PUBLIC INTEREST REVIEW FOR GROUND WATER APPLICATIONS

TO:		Water	Rights	Section				Date	e <u>January</u> 1	12, 2011		
FROM	:	Groun	nd Water	/Hydrology	Section _							
SUBJE	CT:	Appli	cation G	- 17411			ewer's Name persedes r	eview of		Date of Re	view(s)	
οττοι ι	C INT	DECT	DDFCI	IMPTION.	CDOUN	DWATE	D			Date of Re-	view(s)	
OAR 69 welfare, to deteri	90-310-1 safety an mine whe	30 (1) 7 and healt ether the	The Depar h as descr presump	<i>ribed in ORS</i> tion is establi	resume tha 537.525. I shed. OAR	t a proposi Department 690-310-	ed ground staff revie 140 allows	w ground wate the proposed t	ensure the prese er applications u use be modified cies in place at	inder OA or condi	R 690-31 tioned to	0-140 meet

A. GEN	ERAL II	NFORM	ATION:	Applicant's	Name:	City of Ba	ınkş		County:	Washingt	on	
A1.	Applica	nt(s) see	ek(s) <u>0.0</u>	089 cfs f	rom <u>1</u> w	ell(s) in th	e Wil	lamette				Basin,
		Fualatii							Forest			
A2.	Propose	ed use: _	Irr	igation		Seas	onality:	June 1 – Se	ptember 30			
A3.	Well an	d aquife	er data (at	tach and nu	mber logs				wells as such t			
Well	Log	Logid Applicant's Well #			Proposed Aquifer*		ed (Location (T/R-S QQ-Q)		Location, metes and bound 2250' N, 1

Water Levels in Nearby Wells

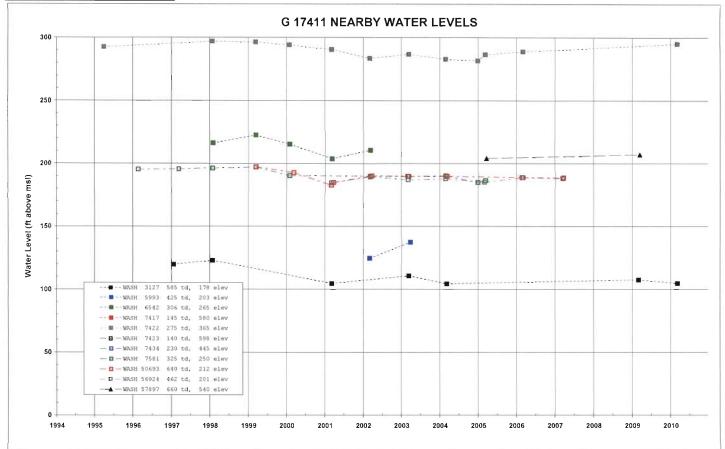
ater levels in nearby wells do not show any obvious signs of decline (see attached hydrograph).										
_											
-
